From: Khanna, Meena *MEK*
Sent: Friday, September 09, 2011 11:09 AM
To: Ulses, Anthony; McMurtray, Anthony; Dennig, Robert; Mendiola, Anthony; Pelton, David; Fairbanks, Carolyn; Lupold, Timothy; Mitchell, Matthew; Pham, Bo; Murphy, Martin; Casto, Greg
Cc: Kulesa, Gloria; Martin, Robert; Wood, Kent; Clifford, Paul; Bedi, Gurjendra; Cheruvenki, Ganesh; Manoly, Kamal; Wilson, George; McCoy, Gerald; Franke, Mark; Holian, Brian; Giitter, Joseph; Galloway, Melanie; Evans, Michele; Lubinski, John; Howe, Allen; Lund, Louise; Ruland, William; Bahadur, Sher
Subject: North Anna Seismic Issue - Path Forward for Restart
Attachments: The KK report .pdf; Untitled
Importance: High

Following today's meeting with Dominion Resources, I propose a process for the forthcoming review of the licensee's basis for restarting the two North Anna units. The discussions today indicate that many staff have given thought to the issue and currently have questions that will require an answer to support the restart review.

Analysis flow path

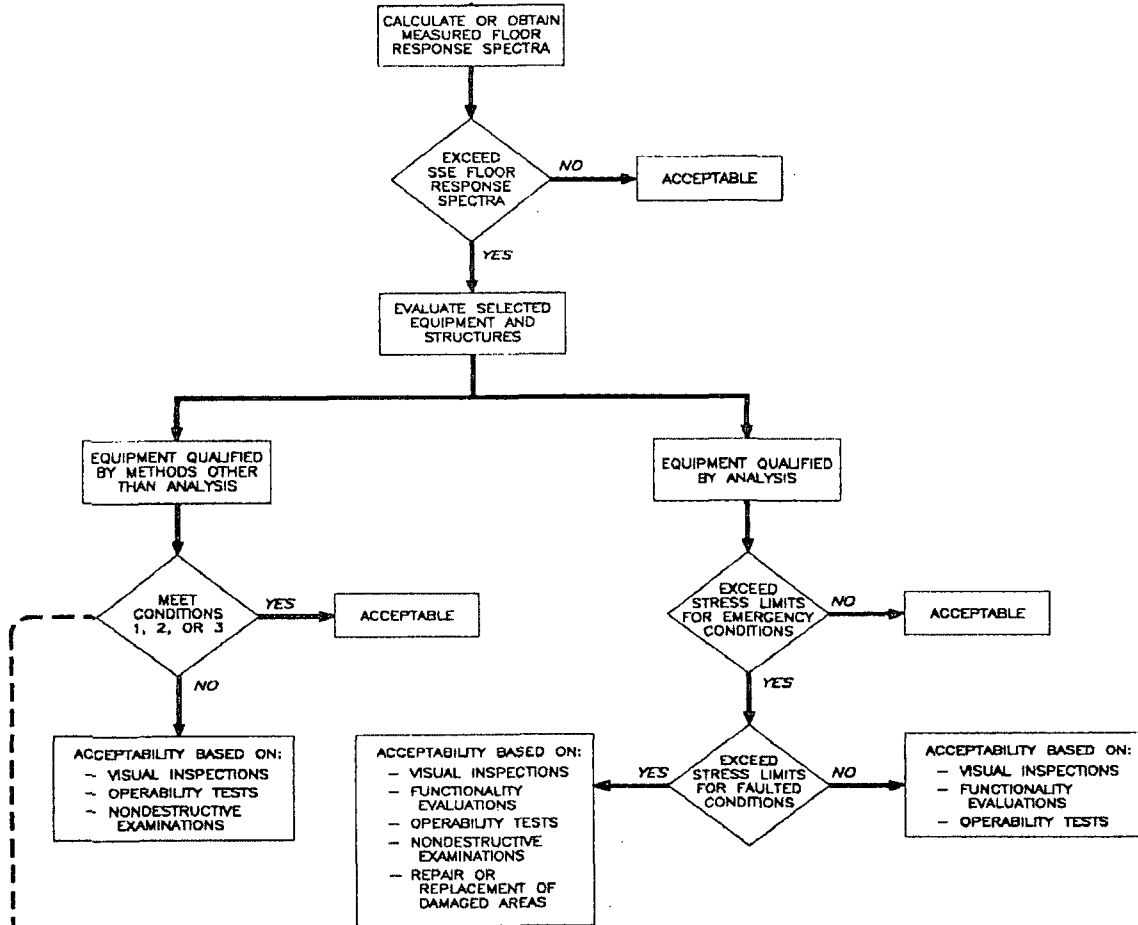
CONDITIONS:

1. TRS EXCEEDS FLOOR RESPONSE SPECTRA BASED ON ACTUAL EARTHQUAKE RECORD.
2. GERS DIVIDED BY 1.3 EXCEEDS FLOOR RESPONSE SPECTRA BASED ON ACTUAL EARTHQUAKE RECORD.
3. QUALIFIED ON BASIS OF SEISMIC EXPERIENCE DATA.
